ARMY AVIATION TEST BOARD FORT RUCKER ALA
INSTALLATION OF ATTITUDE AND DIRECTIONAL INDICATORS IN OH-23D H--ETC(U)
SEP 63

SUBJECT: Report of Test, USATECOM Project No. 4-3-3850-01-G,
Installation of Attitude and Directional Indicators in
OH-23D Helicopters

INSTALLATION OF ATTITUDE AND DIRECTIONAL INSTRUMENTS
IN OH-23D HELICOPTERS

FIGURE I-6

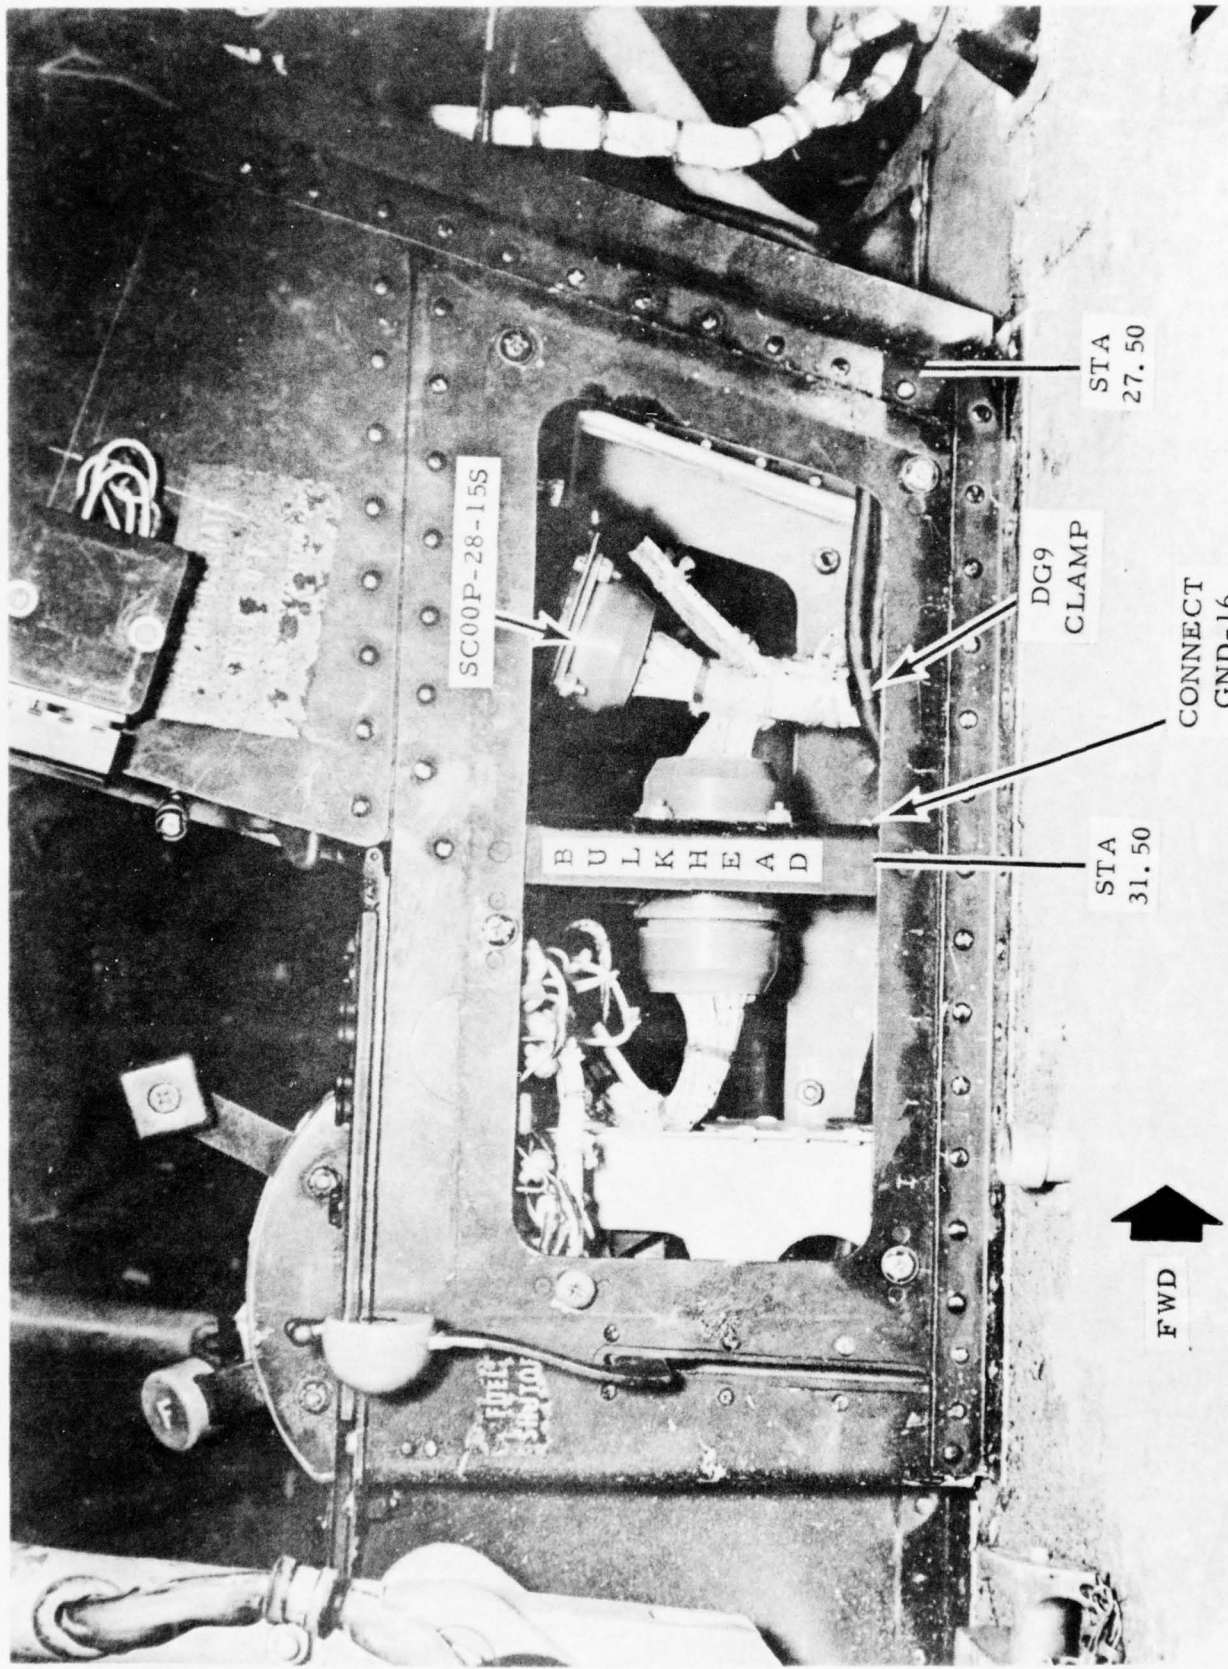
(f) Route Wire V1A22 along existing wiring through grommet hole at Station 27.50 and aft to the receptacle (SC00P-28-15S) at Station 31.50 in control pedestal tunnel. (See Figure I-6.)

(a) Locate Spare Wire d-16 in receptacle (SC00P-28-15S) (see Figure I-6) and connect to GND-16 with one red splice connector (AMP No. 320559).

(c) Connect Wire GND-16 to the bulkhead (utilize existing hole) using one screw (AN515DD832R8), three washers (AN960PD8), and one nut (AN365D832A). NOTE: Use a bonding brush to insure proper grounding. (See Figure I-6.)

(g) Following existing cables, route harness through the bulkhead grommet holes at Stations 44.75, 39.25, 35.25, 31.50, and 27.50. String-tie as required. Replace existing clamp at Station 30.0 with one clamp (MS21919DG9), using existing hardware. (See Figure I-6.)

FIGURE I-9

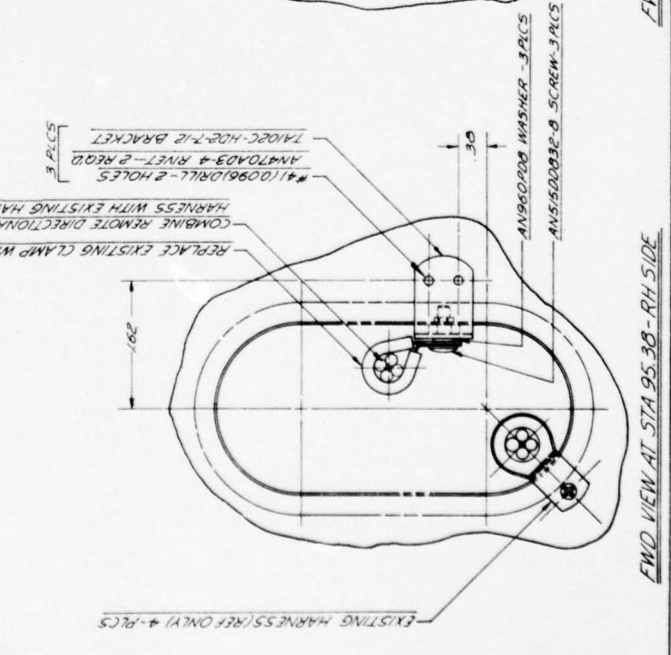
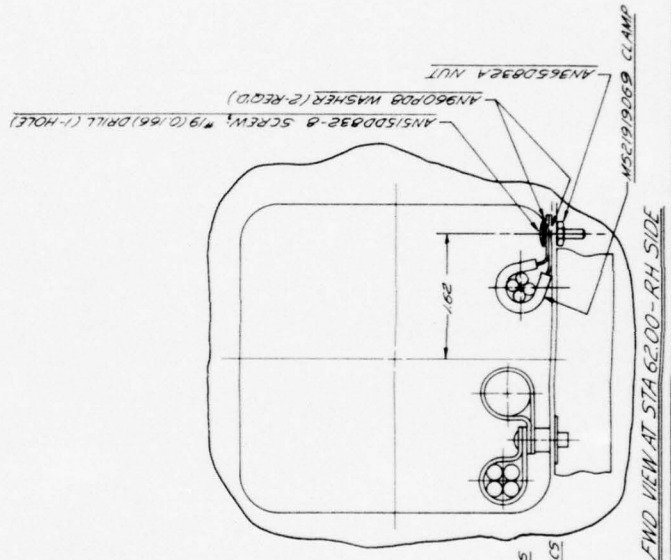
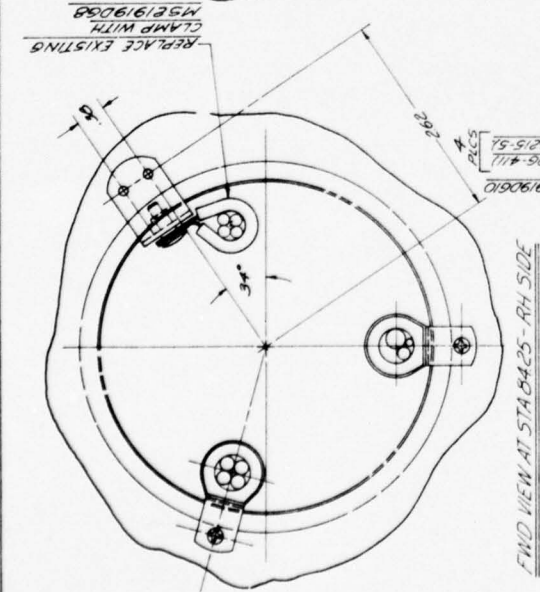
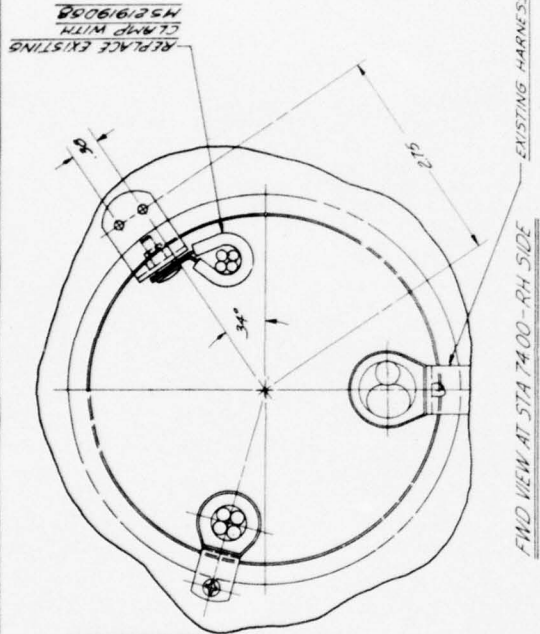
(d) Secure the support bracket to the tailboom assembly with 12 rivets (AN470AD4-5), 2 rivets (AN470AD4-7), and 2 rivets (AN470AD4-8). (See Figure I-9.)

(c) Secure the cable harness for the DG-411 Gyro to the support bracket with one clamp (MS21919DG4), one screw (AN515DD832R8), two washers (AN960PD8), and one nut (AN365D832A). (See Figure I-9.)

FIGURE I-11

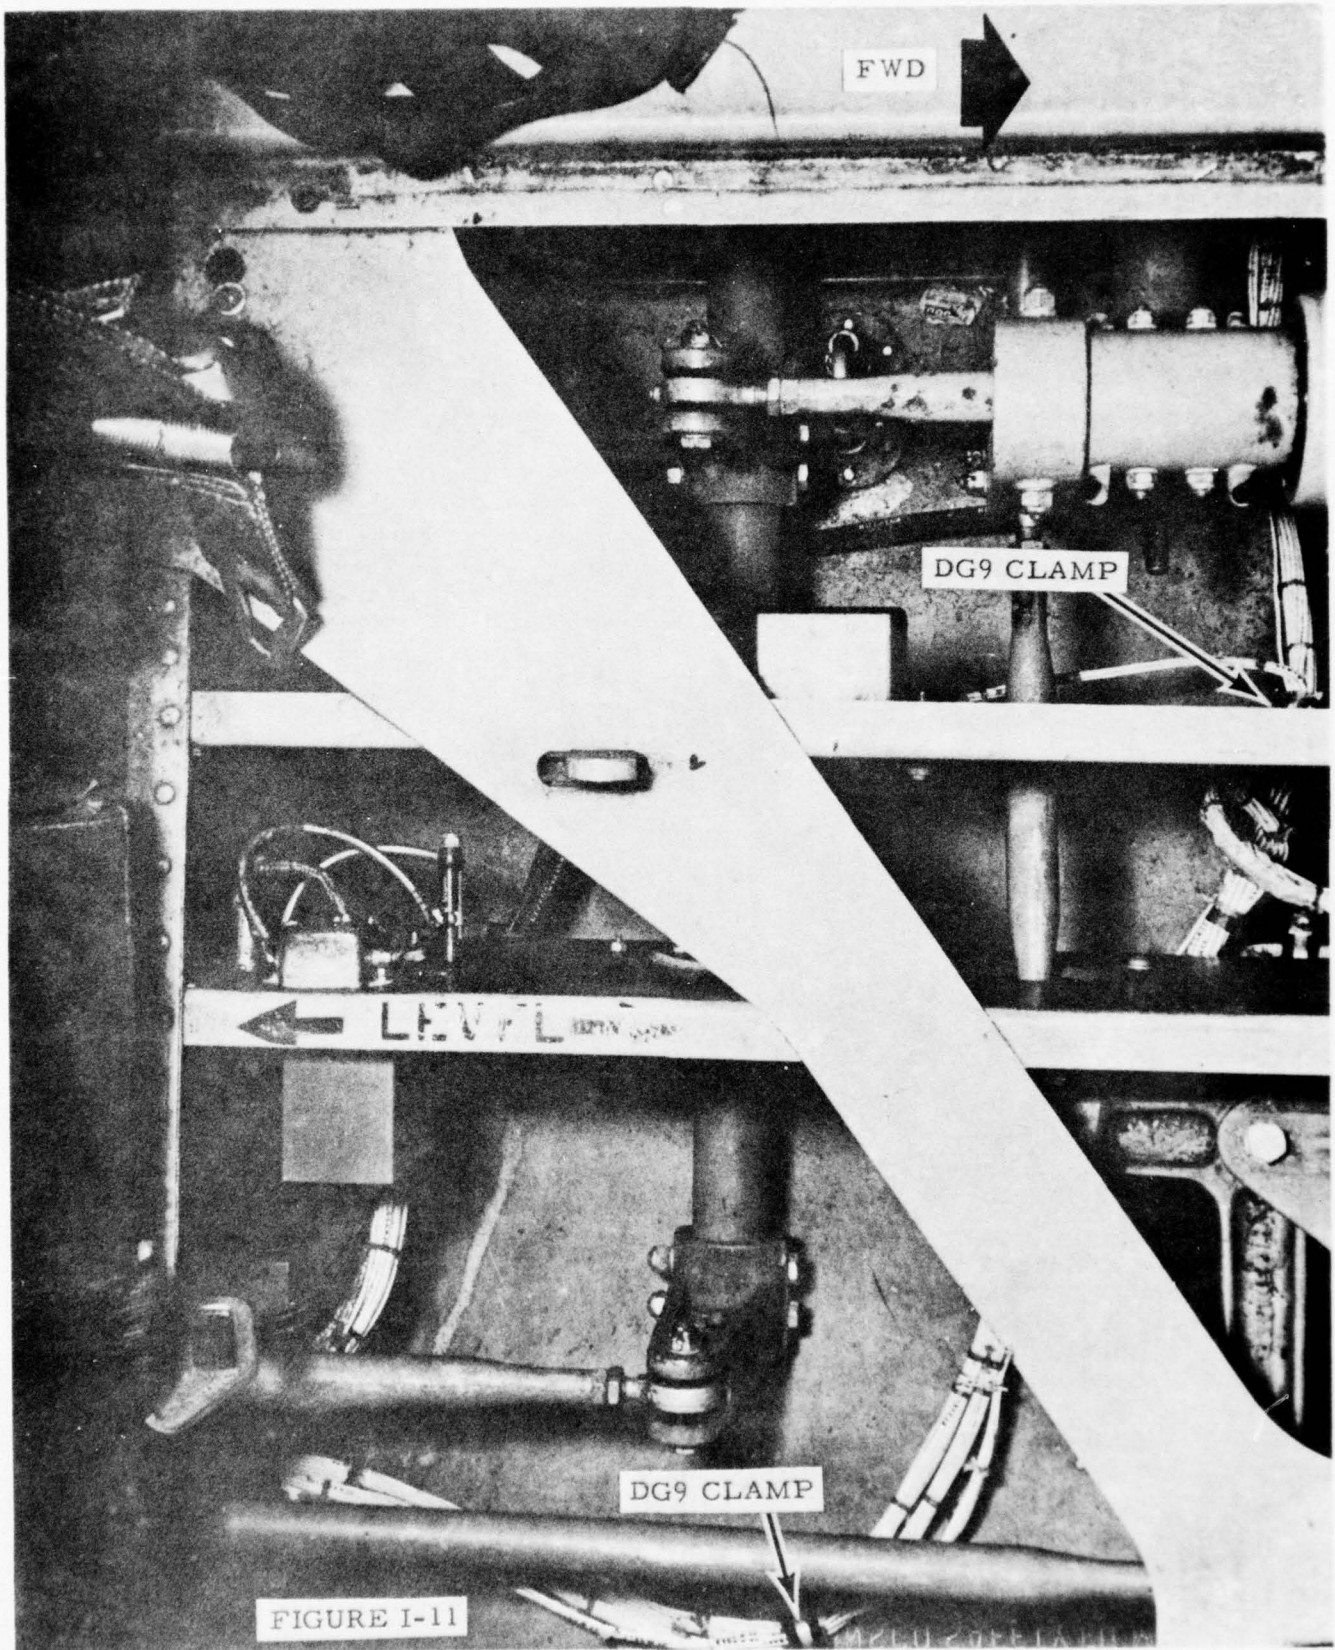
(e) Following existing cable, route harness forward from Station 62.0 to the grommet hole at Station 44.75, B.L. 0.62. (See Figure I-11.)

(f) Tie harness to the existing harness between Stations 62.0 and 44.75 and secure by replacing two existing clamps with two clamps (MS21919DG9), using existing mounting hardware. (See Figure I-11.)

FIGURE I-12

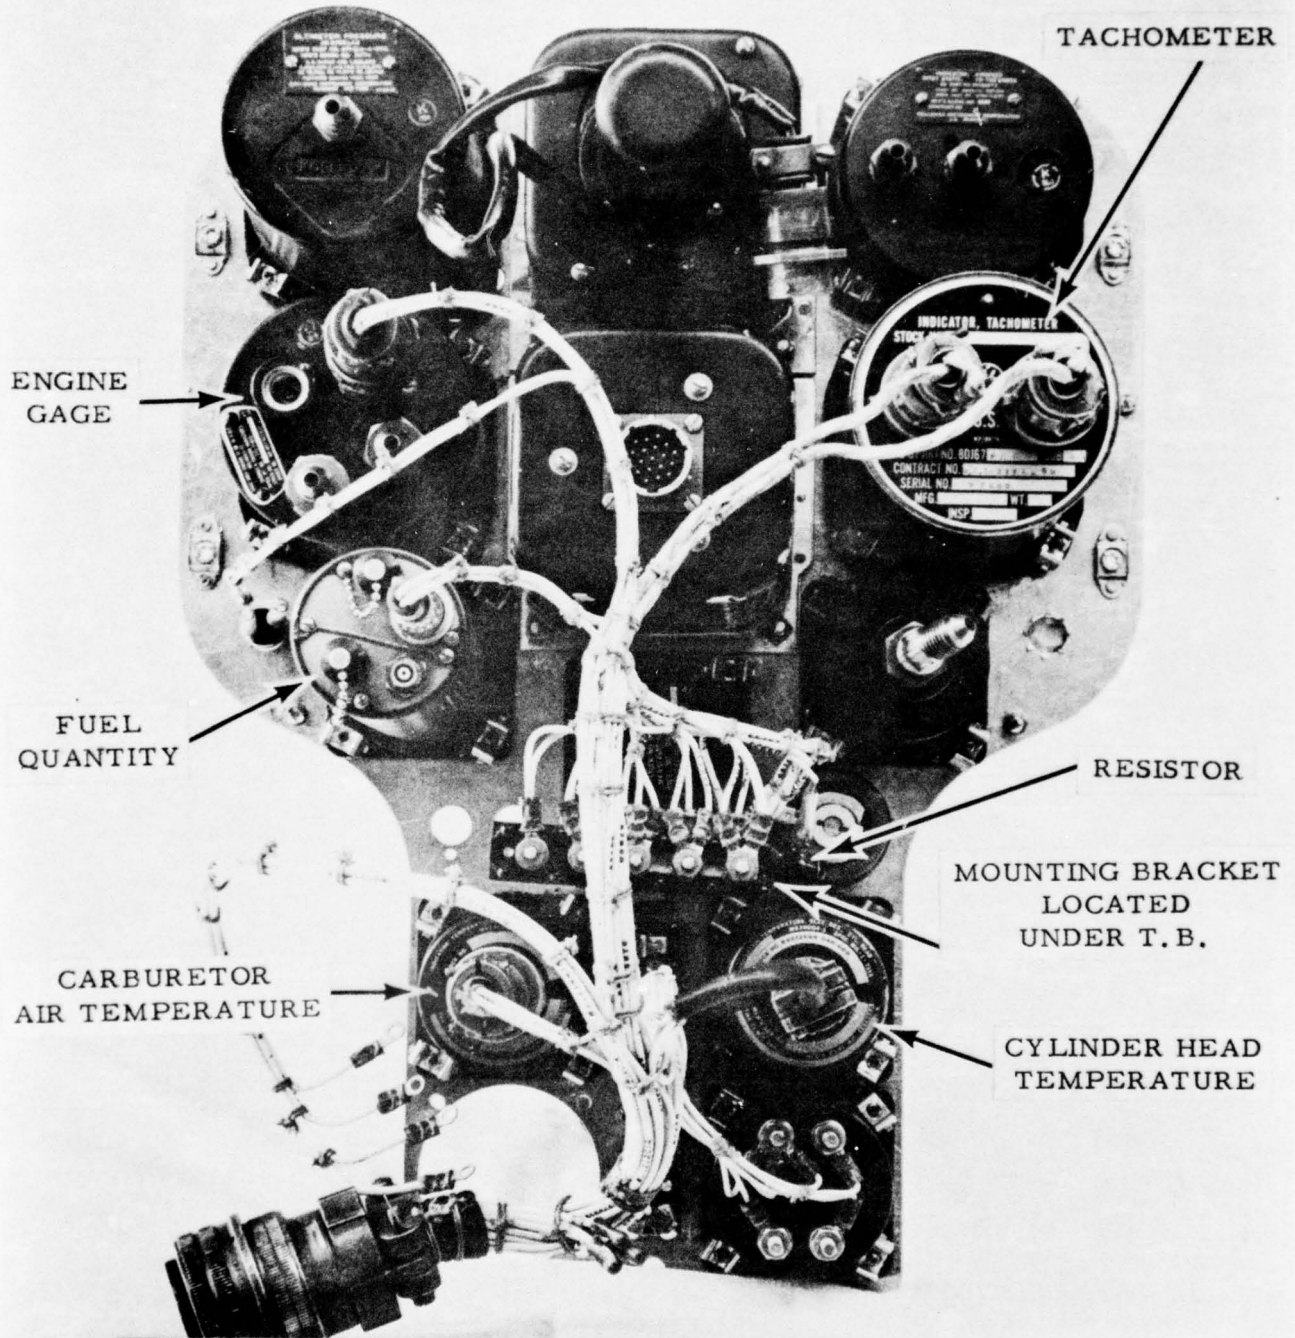
(23) Install Mounting Bracket (Item 12) on front side (inside) of new Instrument Panel Assembly (Item 8), using two screws (AN507B632R6), two washers (AN961-6), and two nuts (AN365B632C). (See Figure I-12.)

(24) Install terminal block (AN3436-2-5) on mounting bracket, using two screws (AN515DD440R6), two washers (AN960PD4L), two nuts (AN365D440A), one insulating strip (AN3434-1), and one buss bar (AN3433-2-3). (See Figure I-12.)

(30) Install Harness Assembly (Item 4) on the new instrument panel as follows: (See Figure I-12.)

FIGURE I-13

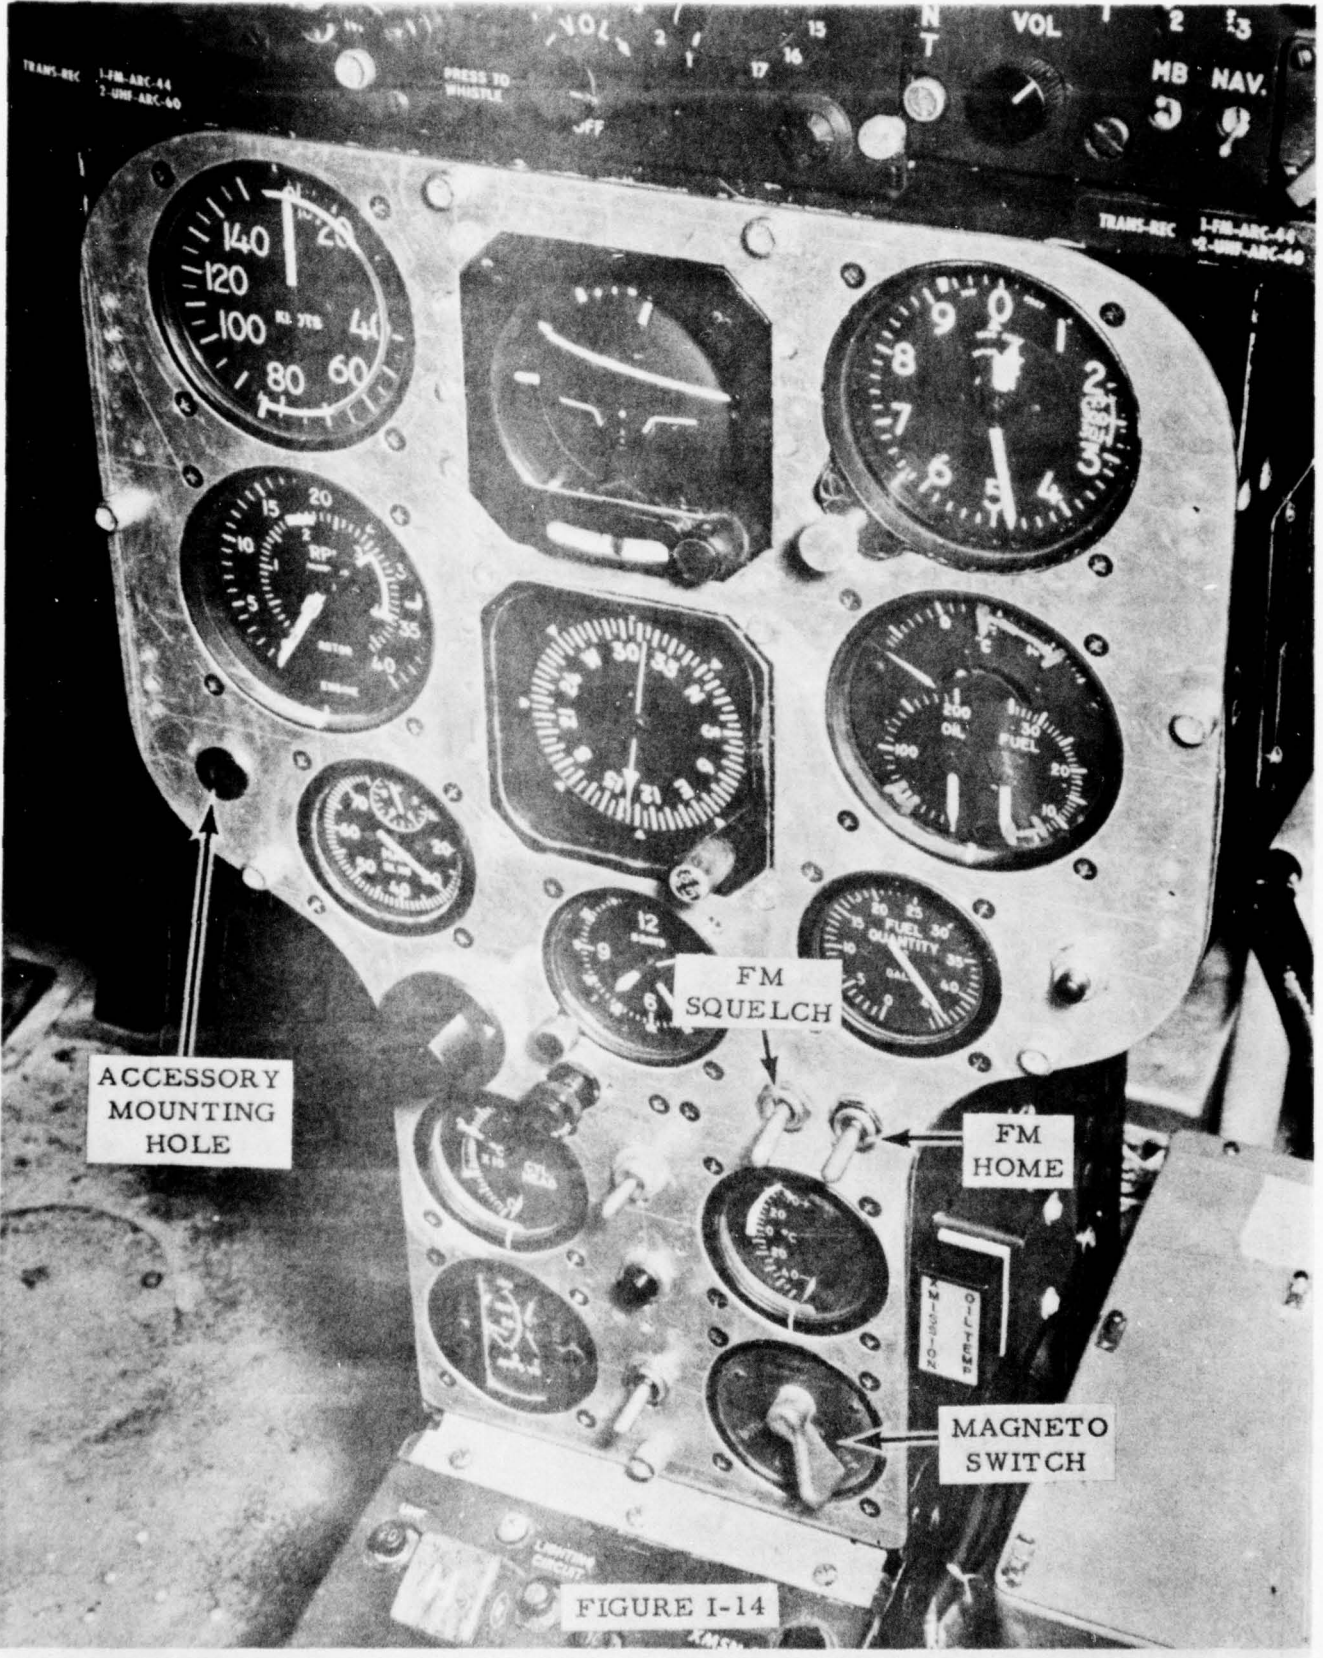
(27) Install new circuit breaker, two amp, (MS25244-2) for LOH System on new instrument panel. (See Figure I-13.)

(28) Install RH-101 Heading Indicator on new instrument panel (see Figure I-13) using one instrument mounting clamp (Aeroquip Corp., Los Angeles 64, California, Part No. 52981) and four screws (AN507B832R20).

(29) Install GH-211 Attitude Horizon Indicator on new instrument panel (see Figure I-13) using one instrument mounting clamp (Aeroquip Corp., Los Angeles 64, California, Part No. 52981) and four screws (AN507B832R20).
